Project	<b>IEEE 802.16 Broadband Wireless Access Working Group</b> < <a href="http://ieee802.org/16">http://ieee802.org/16</a> >	
Title	<b>RS support for OFDMA Based Ranging</b>	
Date Submitted	<b>2006-11-07</b>	
Source(s)	Shashikant Maheshwari, Yousuf Saifullah, Haihong Zheng Nokia 6000 Connection Drive, Irving, TX	Voice: 972 839 1878 Fax: <a href="mailto:shashikant.maheshwari@nokia.com">shashikant.maheshwari@nokia.com</a> , <a href="mailto:Yousuf.saifullah@nokia.com">Yousuf.saifullah@nokia.com</a> , <a href="mailto:haihong.1.zheng@nokia.com">haihong.1.zheng@nokia.com</a>
Re:	This is in response to the call for proposal, 80216j-06_027.pdf, sent out by 802.16j TG.	
Abstract	This contribution proposes RS support for MS Initial and Periodic Ranging in multi-hop system.	
Purpose	Add proposed spec changes.	
Notice	This document has been prepared to assist IEEE 802.16. It is offered as a basis for discussion and is not binding on the contributing individual(s) or organization(s). The material in this document is subject to change in form and content after further study. The contributor(s) reserve(s) the right to add, amend or withdraw material contained herein.

## RS support for OFDMA

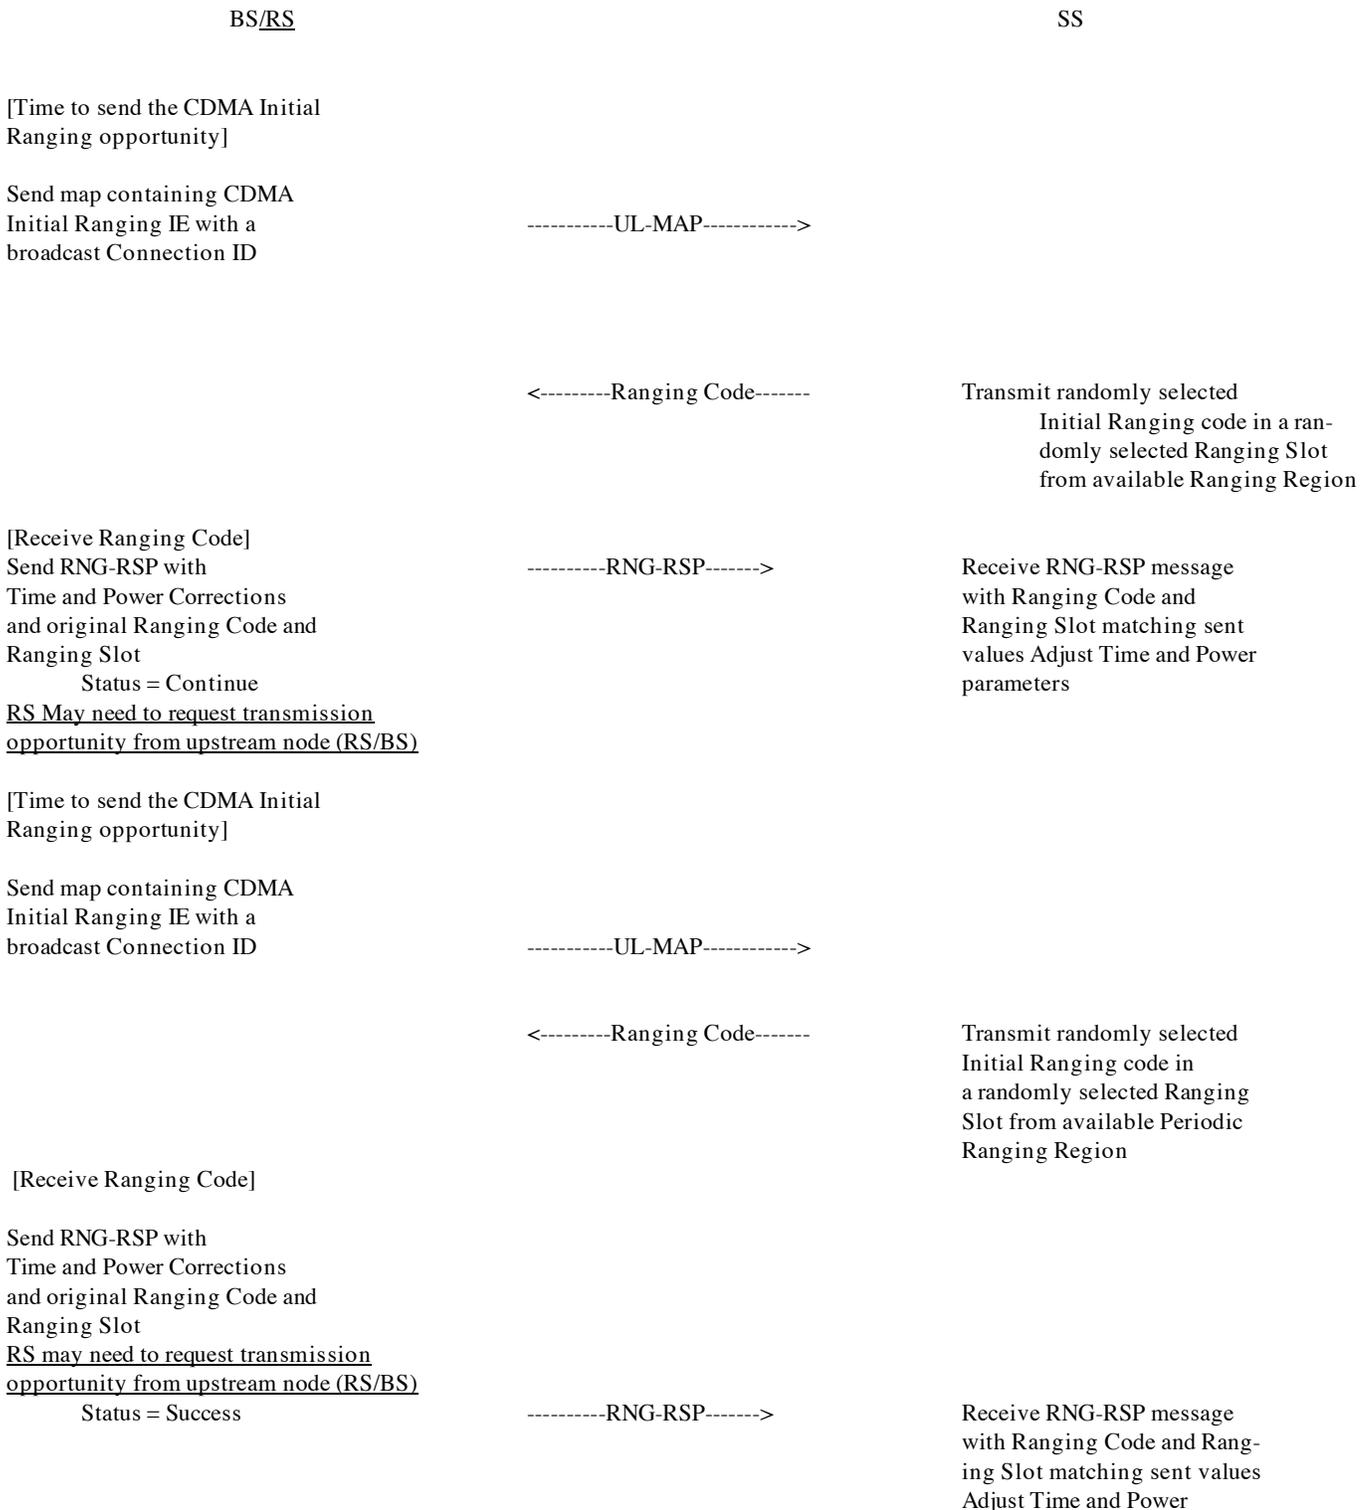
**Change Table 121 as indicated:**

parameters

[Time to send the next map]  
Send map containing  
anonymous BW allocation  
with original Ranging Code  
and Ranging Slot

-----UL-MAP----->

RS May need to request transmission  
opportunity from upstream node (RS/BS)

<-----RNG-REQ-----

Transmit RNG-REQ and  
continue with regular Initial  
network entry

**Figure 87a – CDMA Initial Ranging – RS (centralized scheduling)****6.3.10.3.1 Periodic ranging and automatic adjustments**

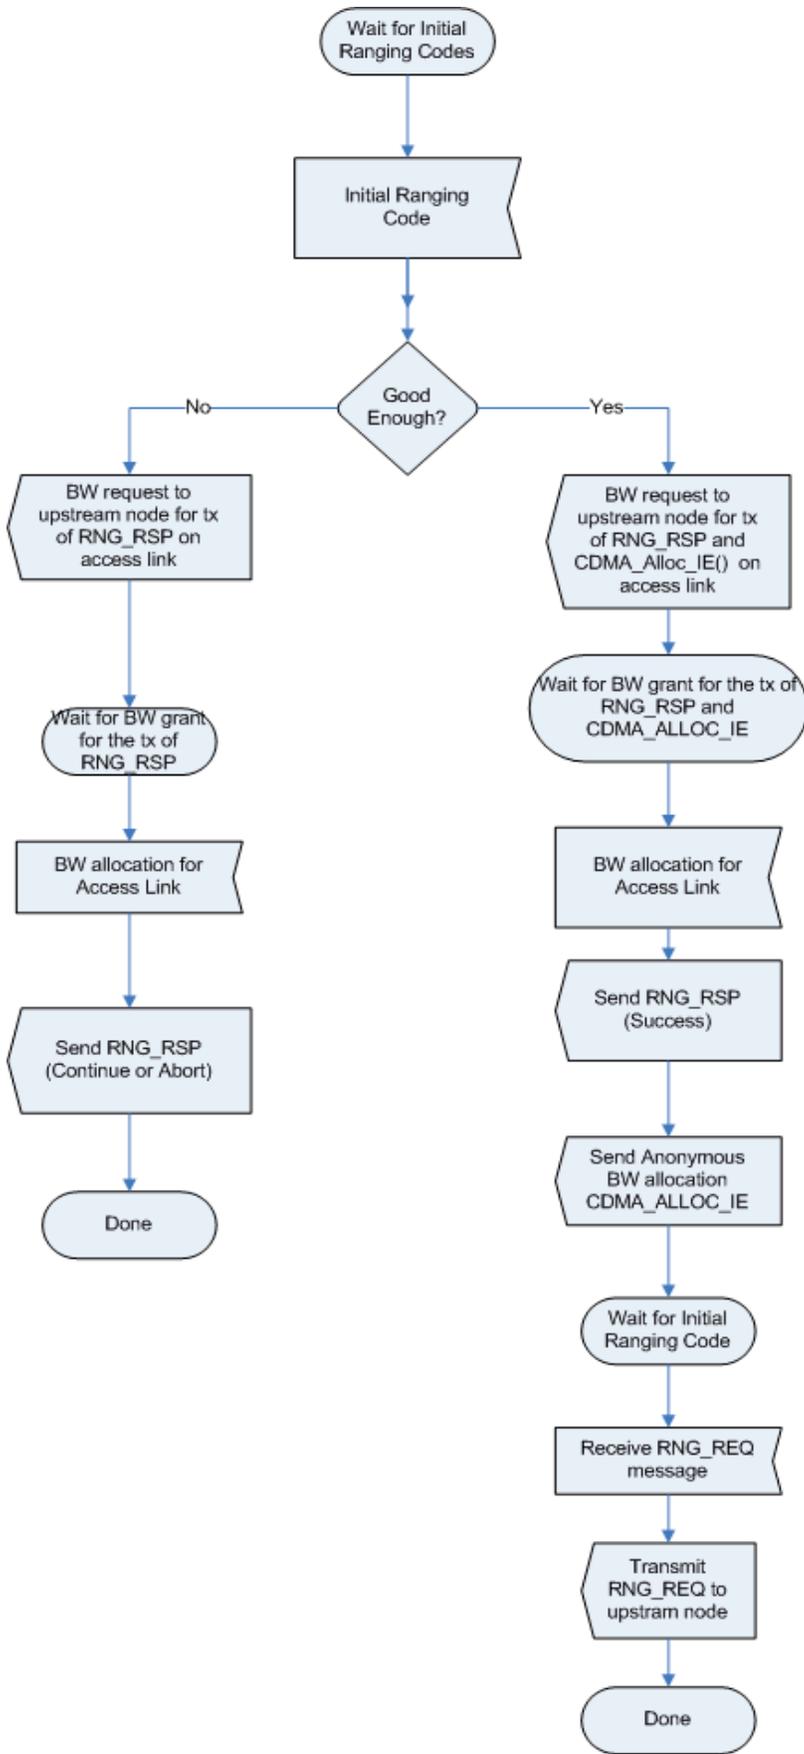
***Insert following new figures 87a***

Figure 89a – CDMA Periodic Ranging – RS (centralized scheduling)

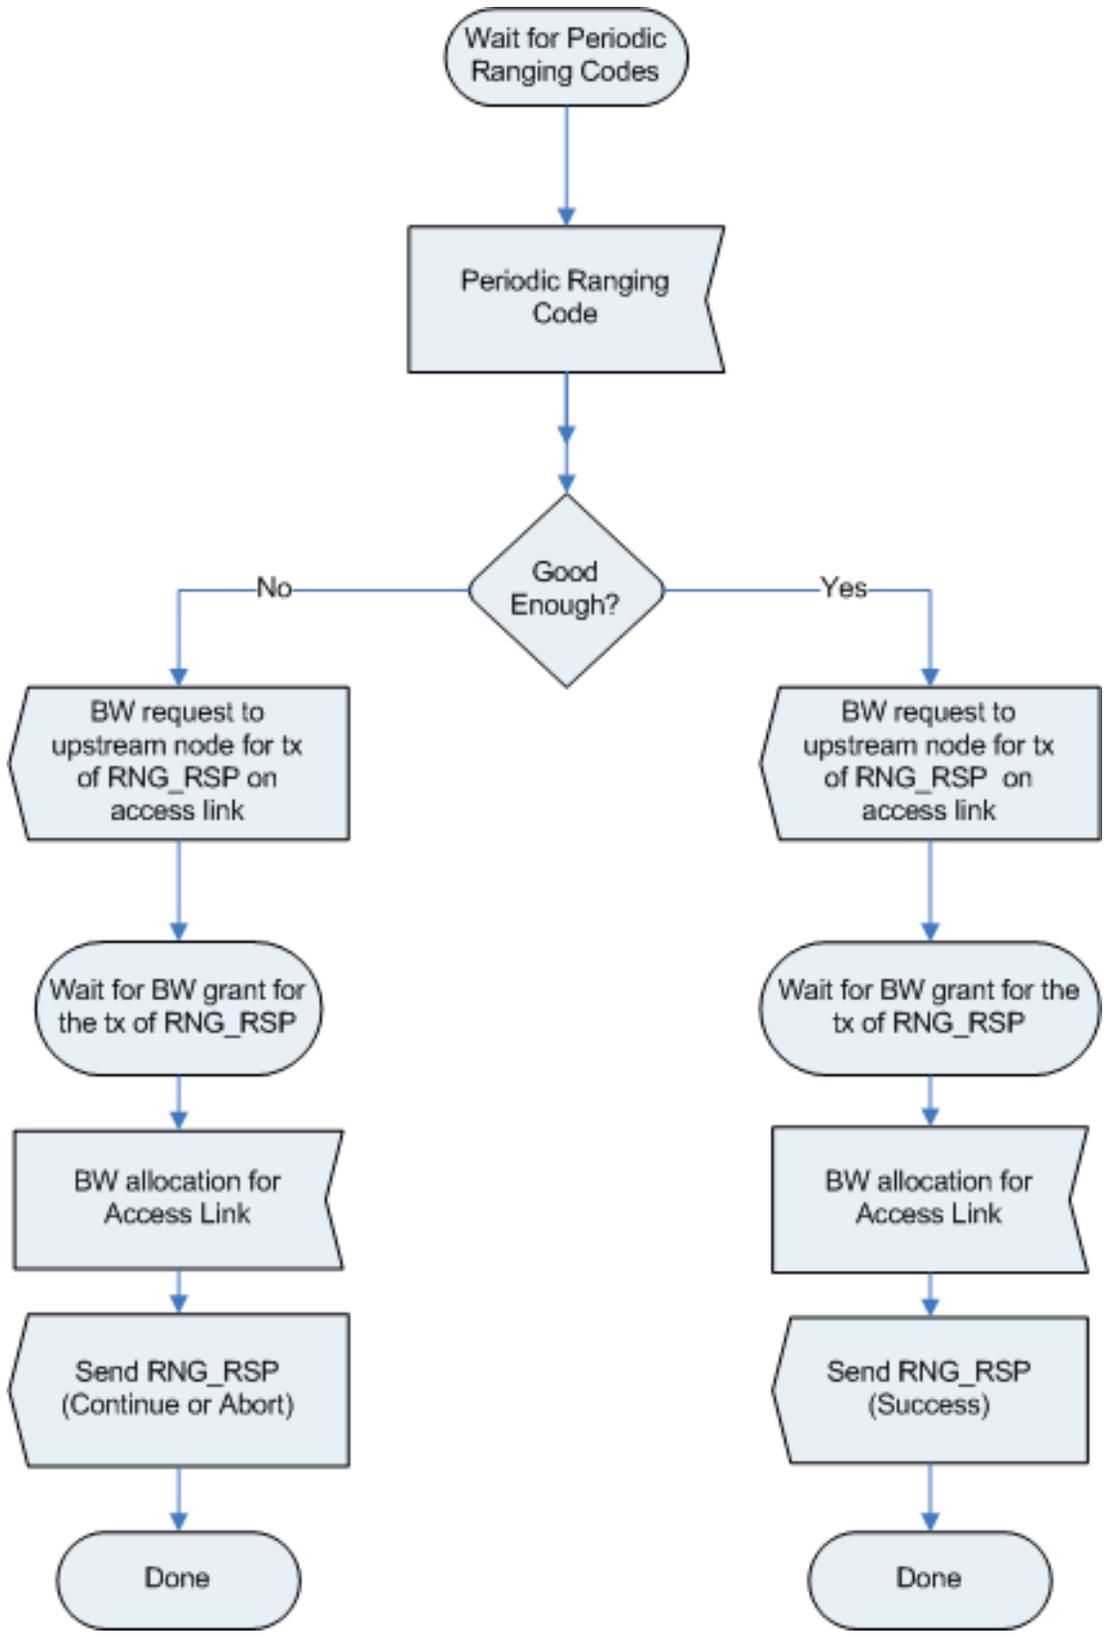
**Insert following new figures 89a**
